PERMANENTE CREEK LONG-TERM RESTORATION PLAN

**Re: Response to Board Comments Letter (dated 11/12/09) [CIWQ Place ID:
234559 (bkw)]
CAO No. 99-018 – Permanente Creek Long-Term Restoration Plan
Lehigh Southwest Cement Company, Cupertino, California**

Response to Board Comments of November 12, 2009
 Permanente Creek Long-Term Restoration Plan
 Lehigh Southwest Cement Company, Cupertino, California

Comments on Permanente Creek Long-Term Restoration Plan (Nov. 12, 2009, CAO 99-018)

Appendix A
Figure 1-3.1 through 1-3.14

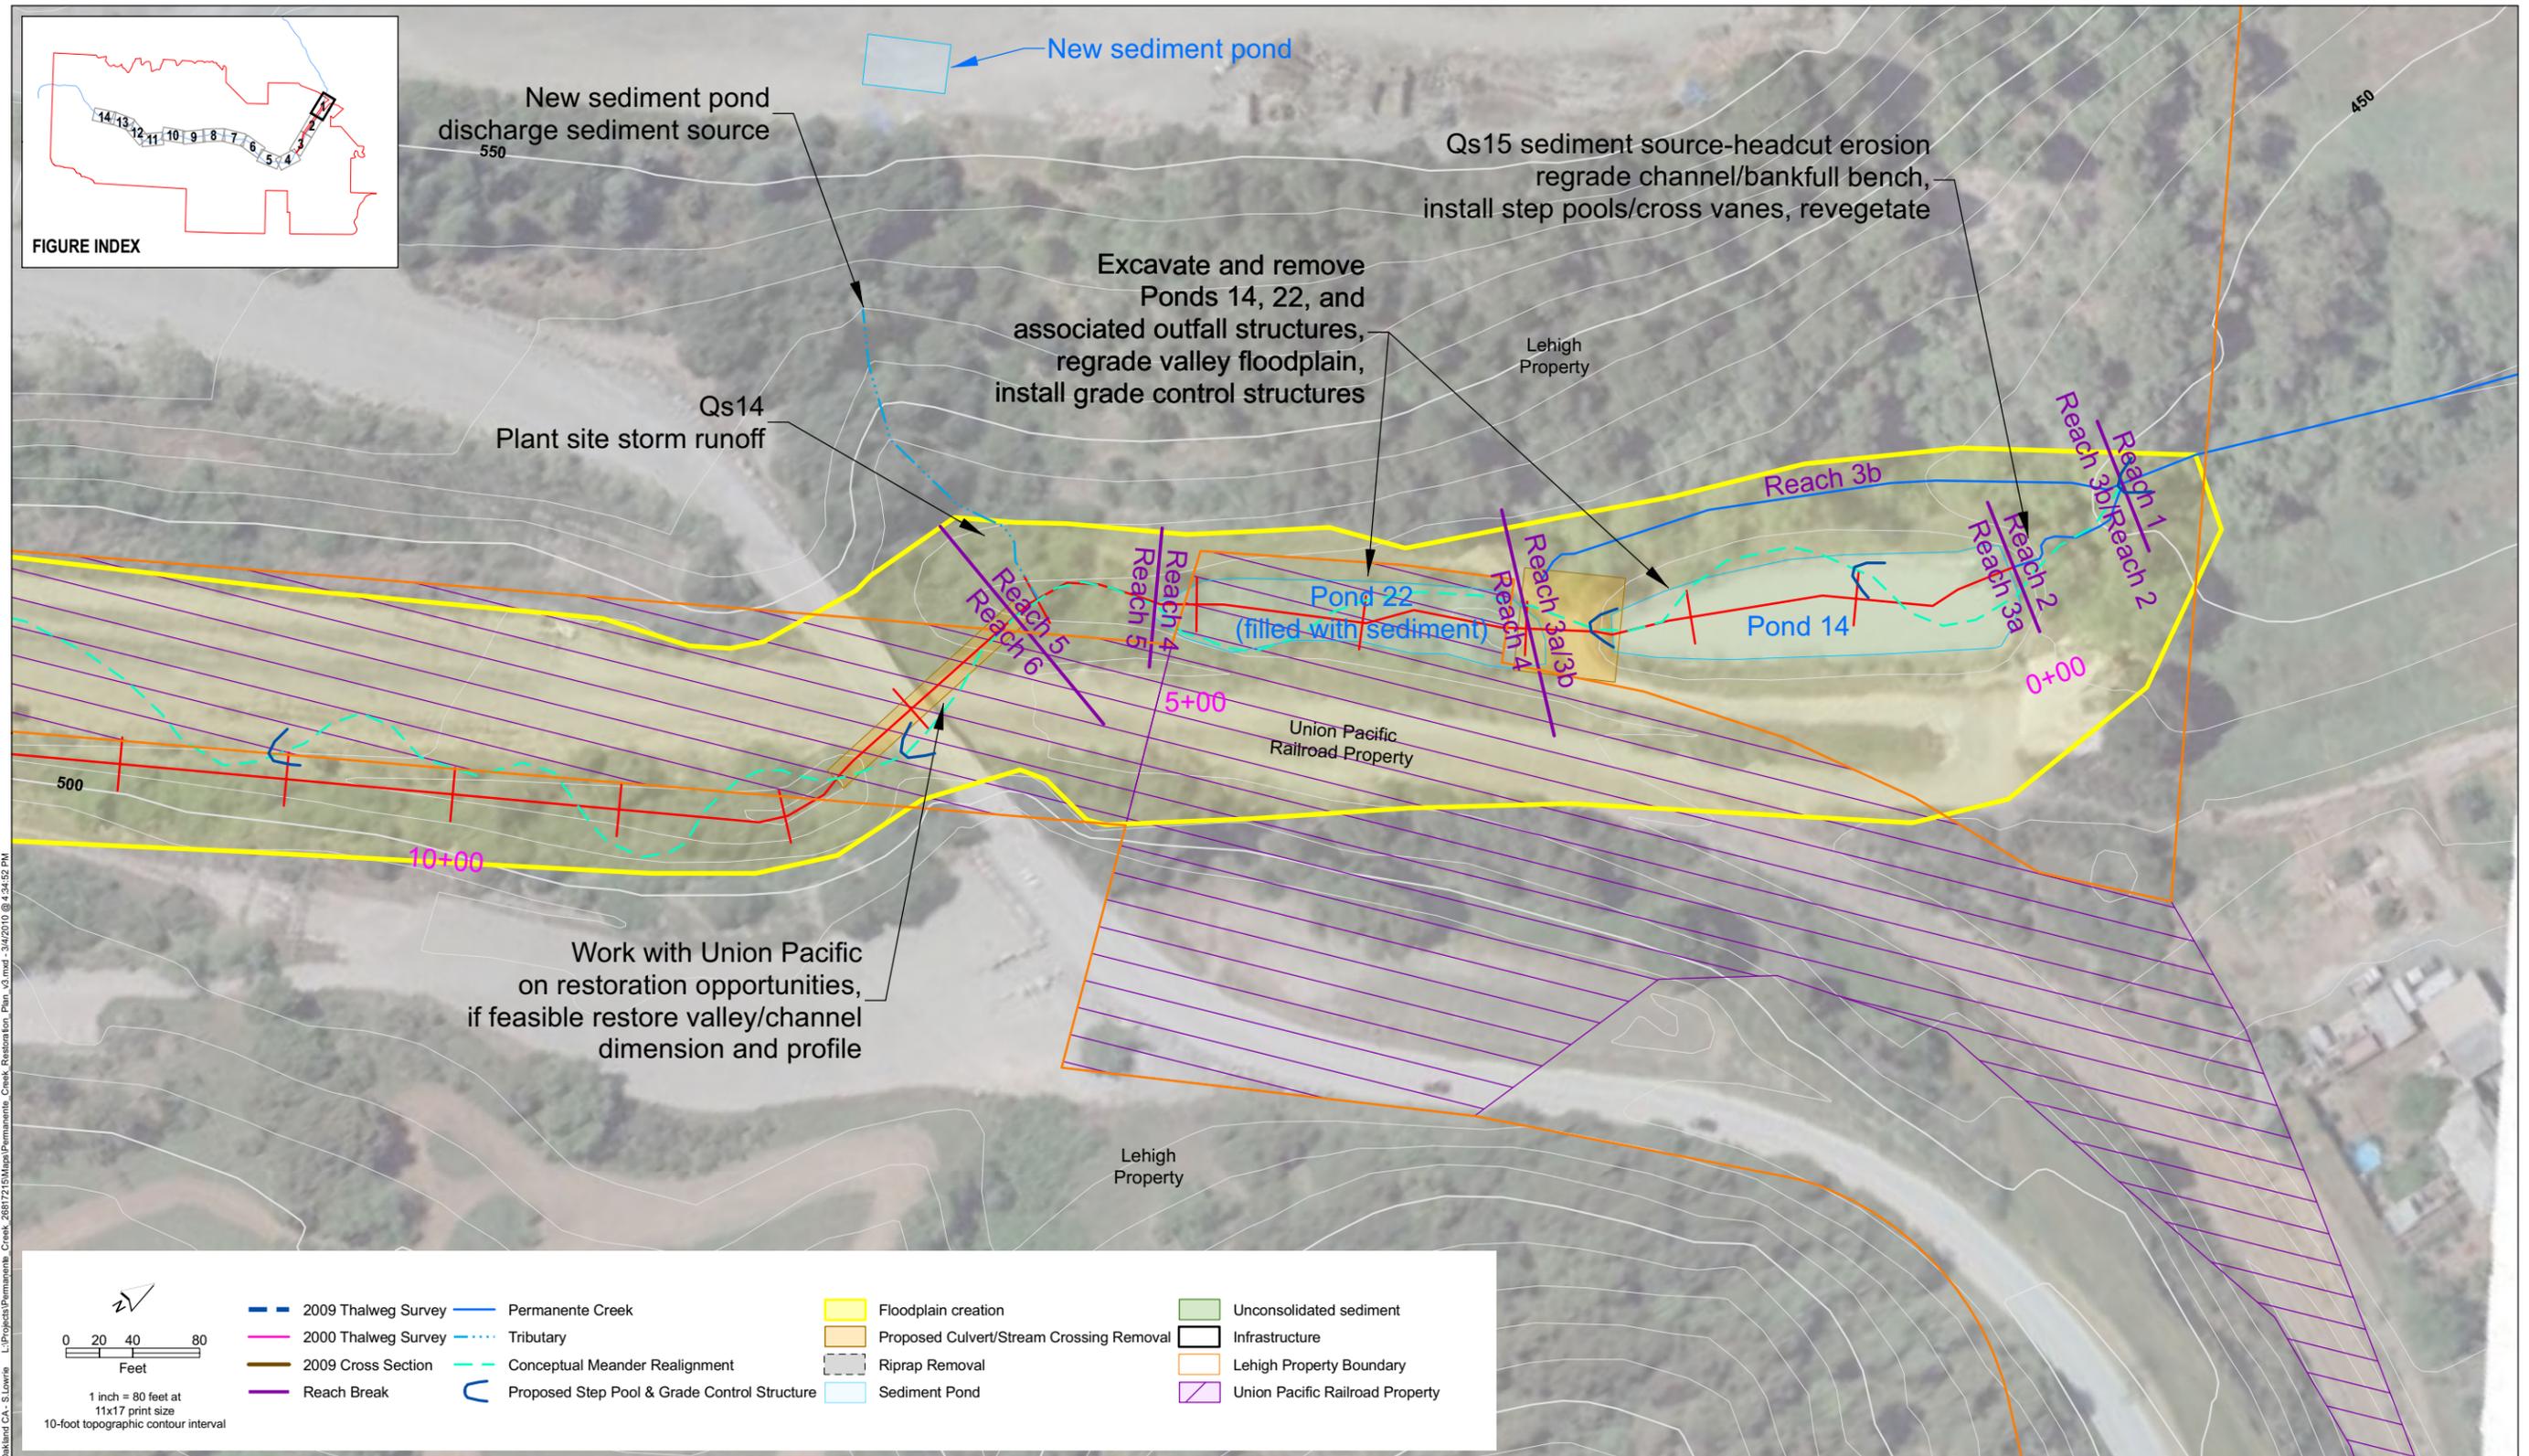
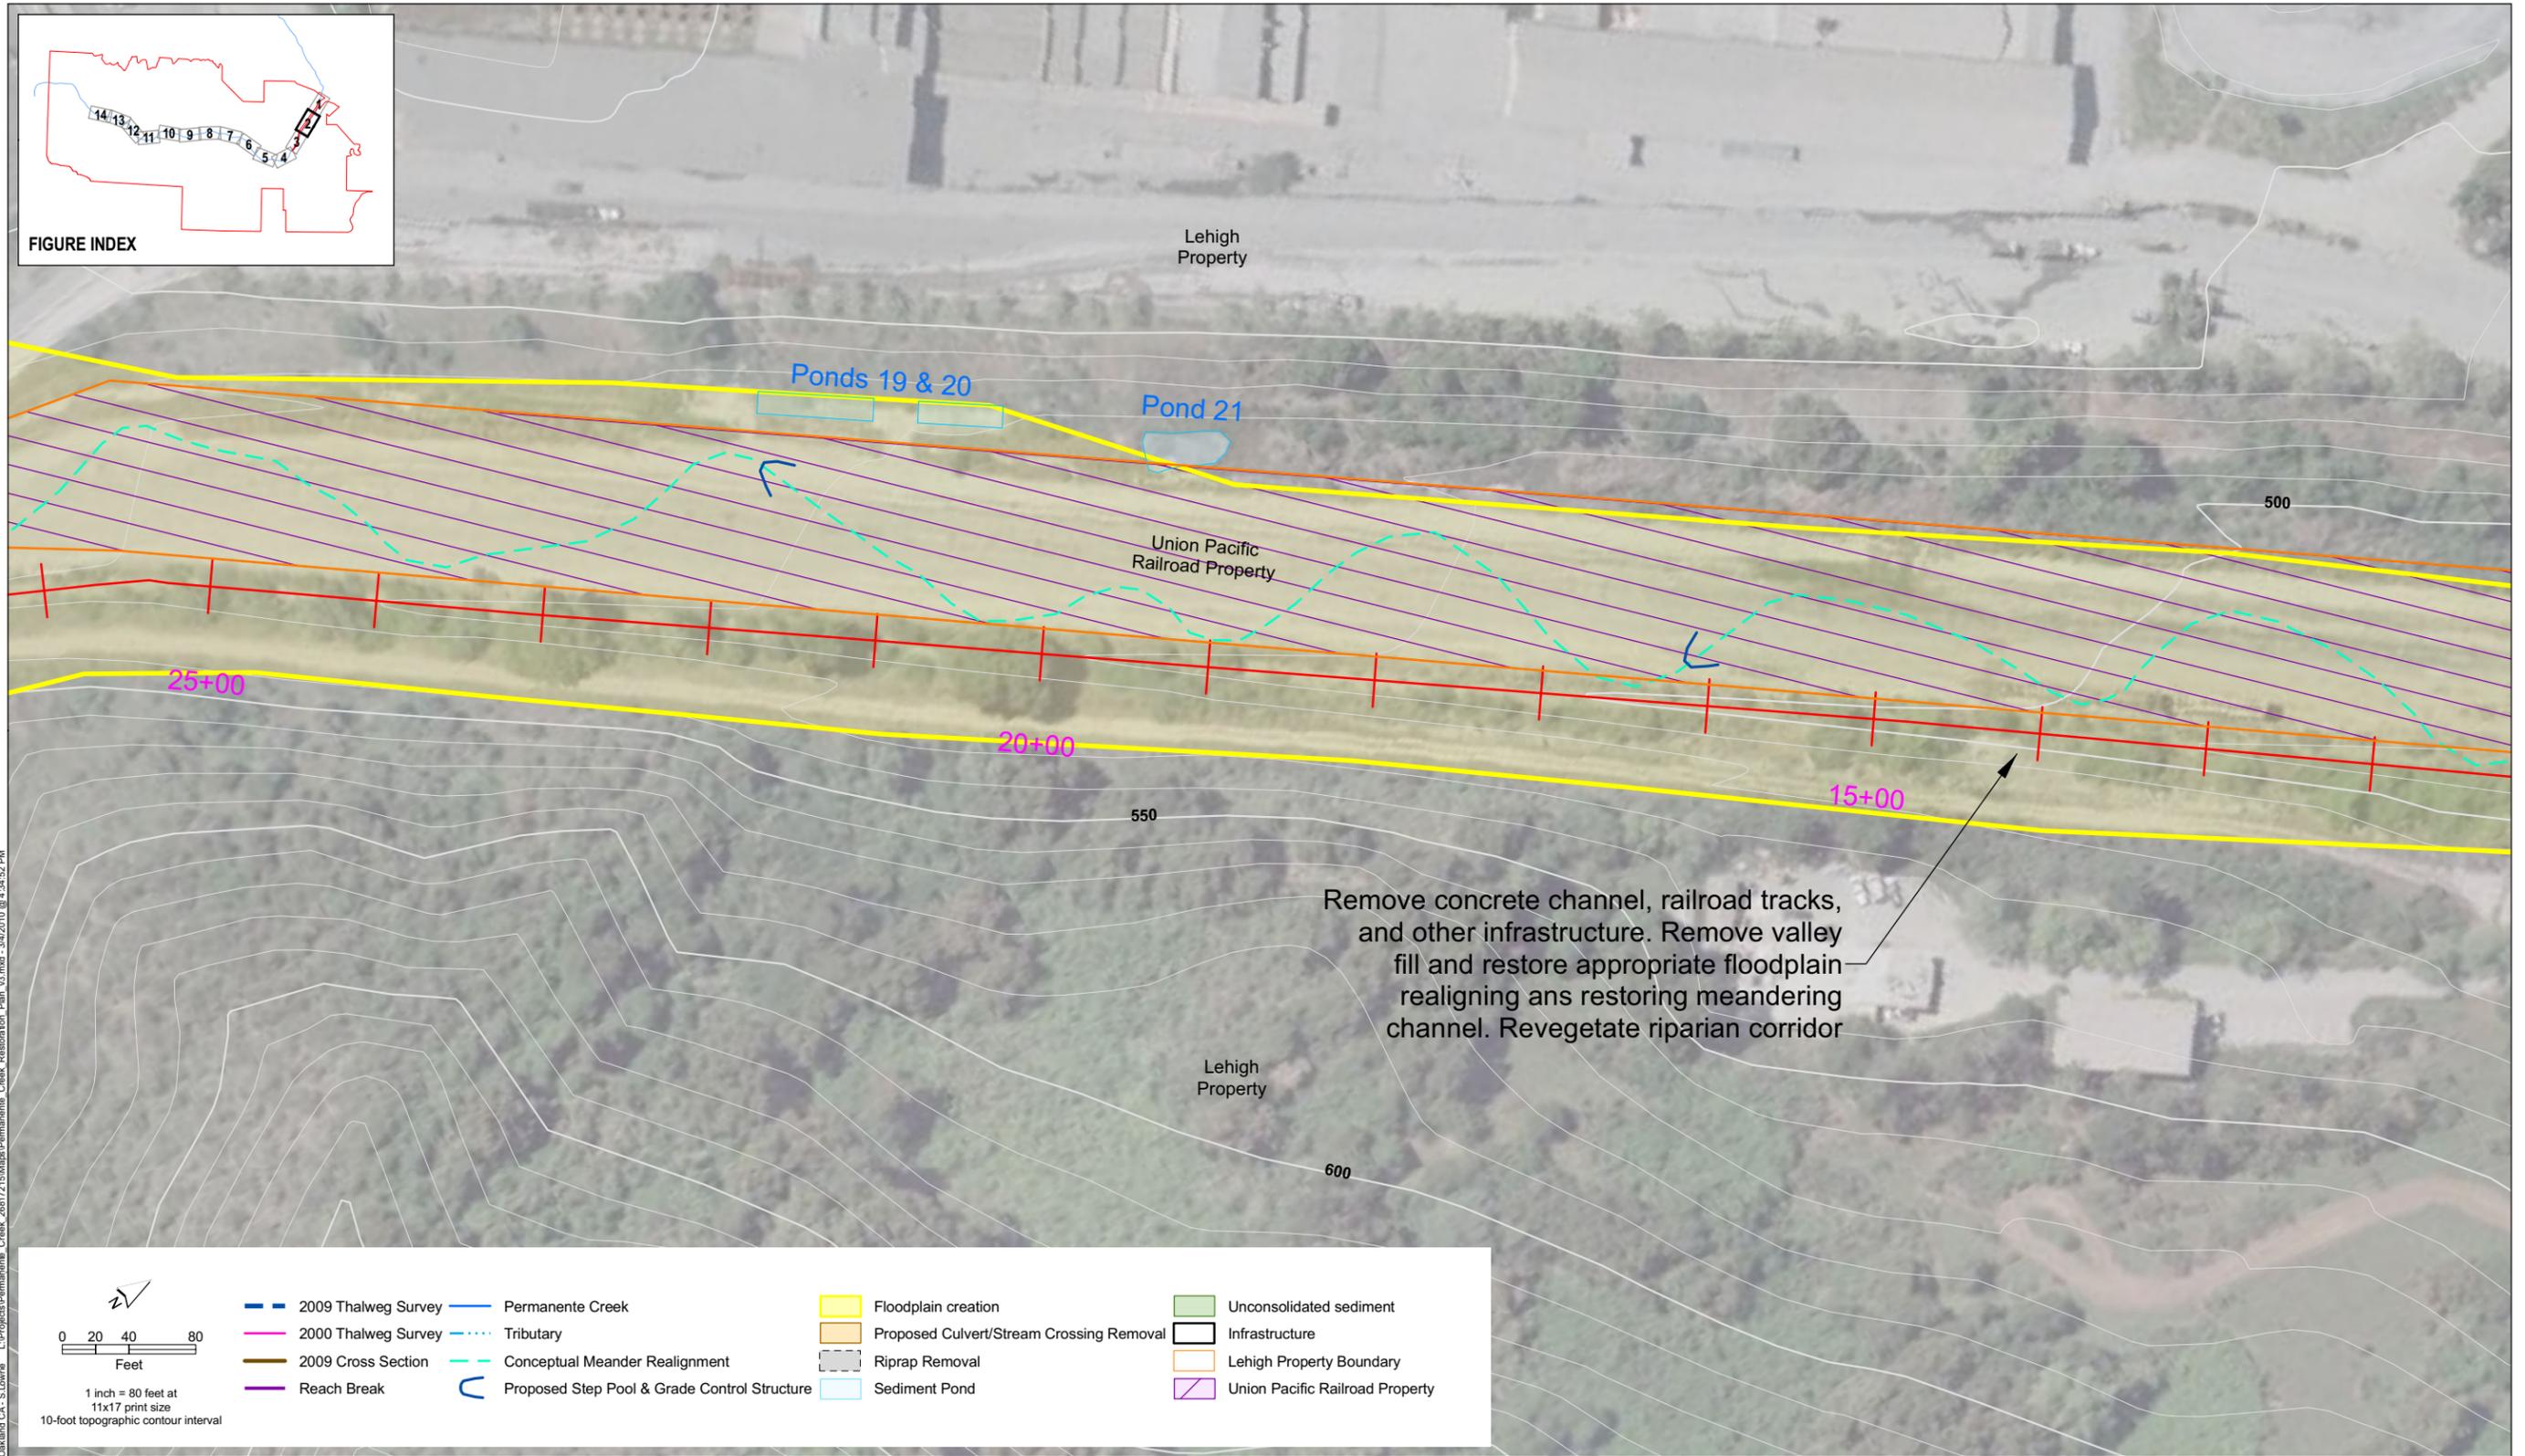
Specific Comment	Document Page	Section	Topic
27	NA	Appendix A	(Figure 1-3)
Comment Text			
The 14 annotated aerial photographs in Figures 1-3.1 through 1-3.14 indicate several significant features (e.g., culverts, ponds). It is not clear if these figures include all in-channel features, or just the in-channel features proposed for removal or modification in the Restoration Plan. Please make sure that all in-channel features are included so that it is easier for Water Board staff to determine if further restoration activities should be assessed for inclusion in the Restoration Plan.			
Comment Response			
The features depicted in Figure 1-3 include all in-channel infrastructure, not just that proposed for removal.

Comment Response			
<p>A new reference system has been simplified. The revised Long-Term Restoration Plan includes cross referencing of the 14 aerial photographs in Appendix A with a new reach designation system. The location nomenclature formerly used in the previous draft, [A] through [R], is no longer used. Please see Table 4-2 and Figure 1-3, where these changes have been implemented. In addition, a new appendix (Appendix B) has been added that correlates the reach nomenclature from the Phase I Report with that of the revised Plan.</p>
